VARIANCE REQUEST

Iowa Department of Natural Resources

RE: Lift Station Trash Basket

DATE PREPARED 6-18-99	PROJECT IDENTITY Proposed Lagoon Lift Station Improvements New London, Iowa 1999	DNR USE PROJECT NO.
DATE REVISED		PERMIT NO.

SITE LOCATION

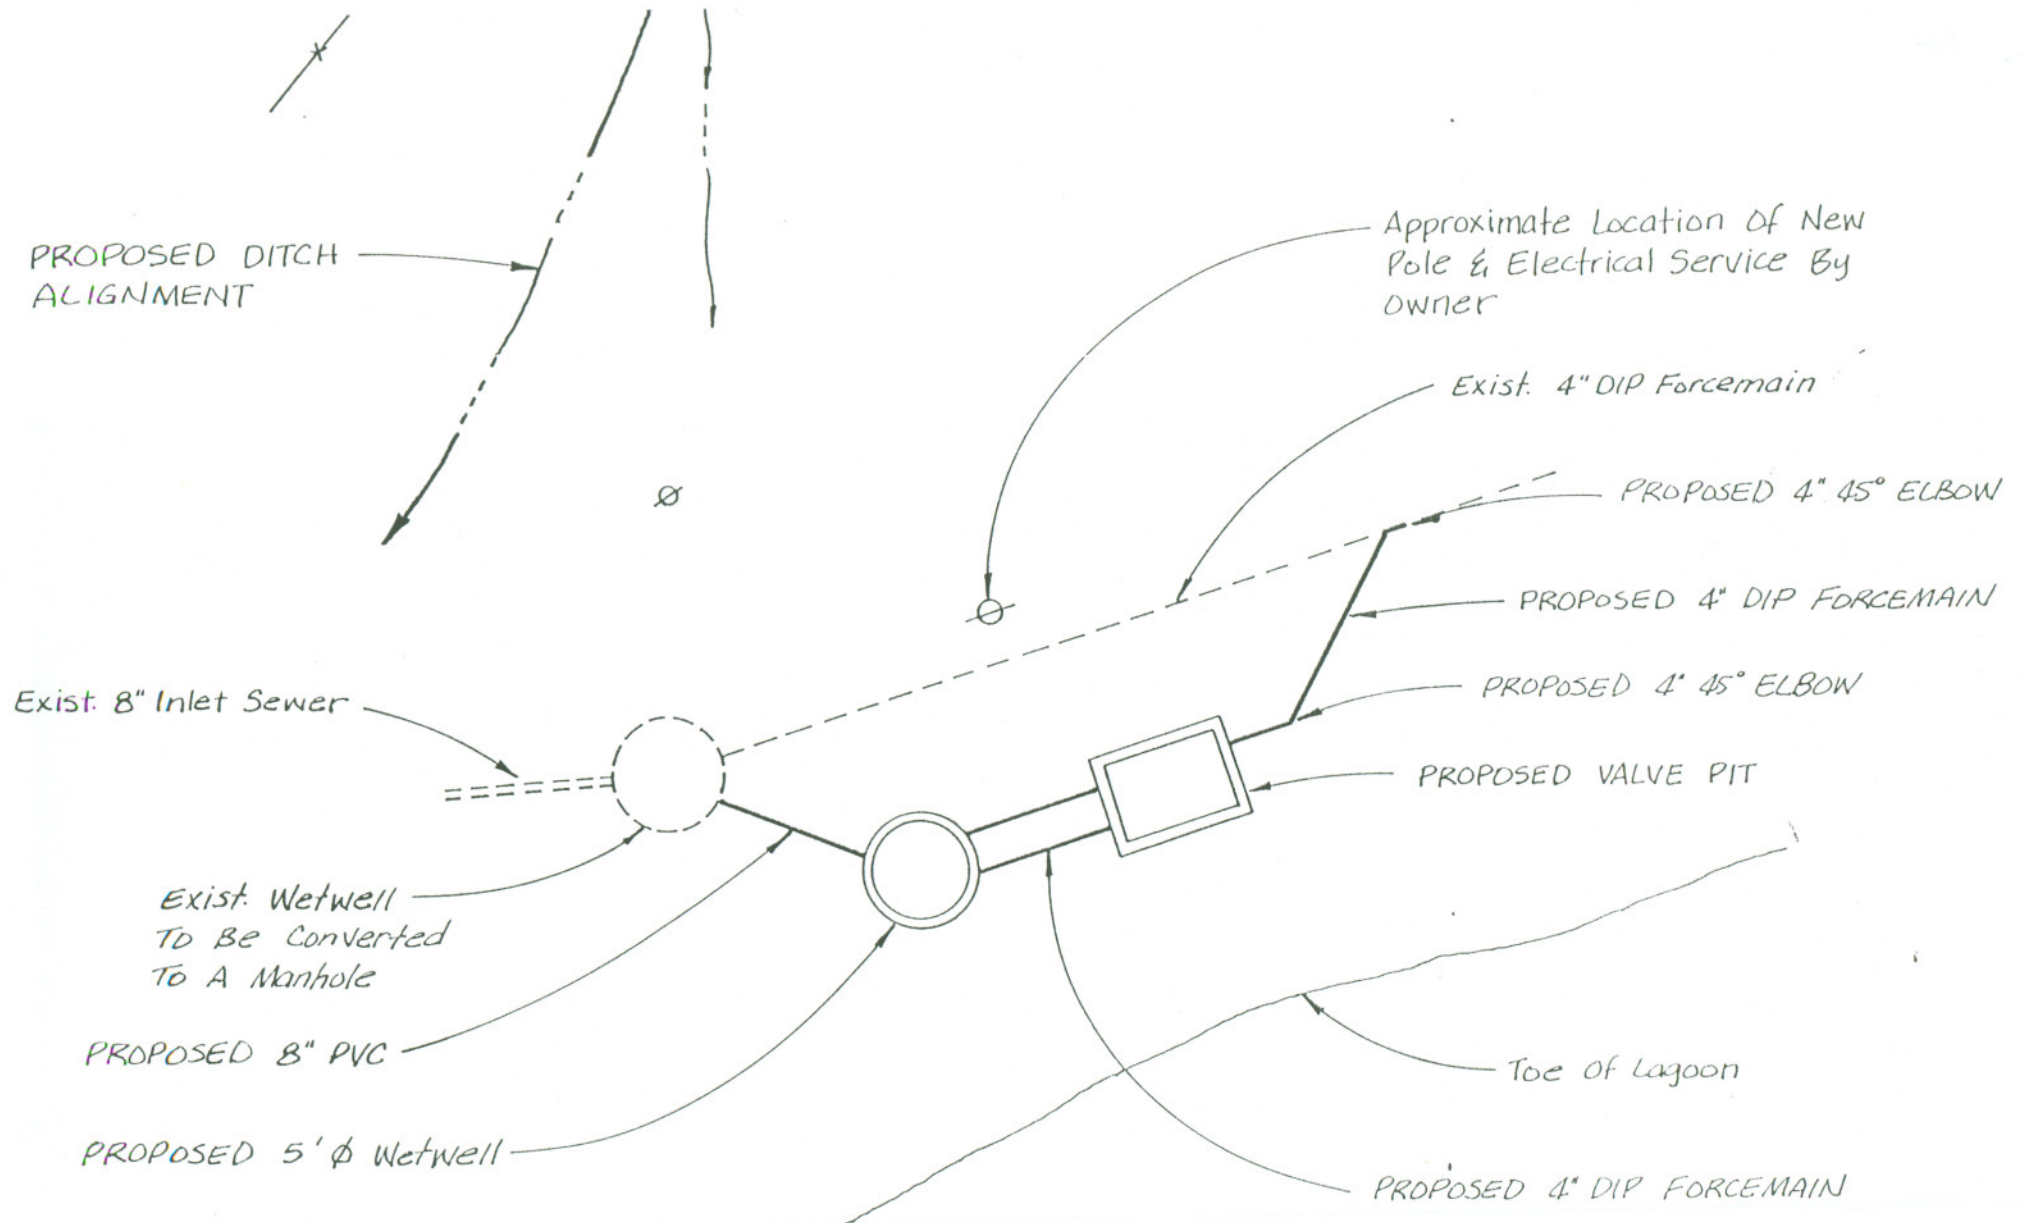
NOTE: Top of Exist. Wetwell
is 714.6. Use As Site
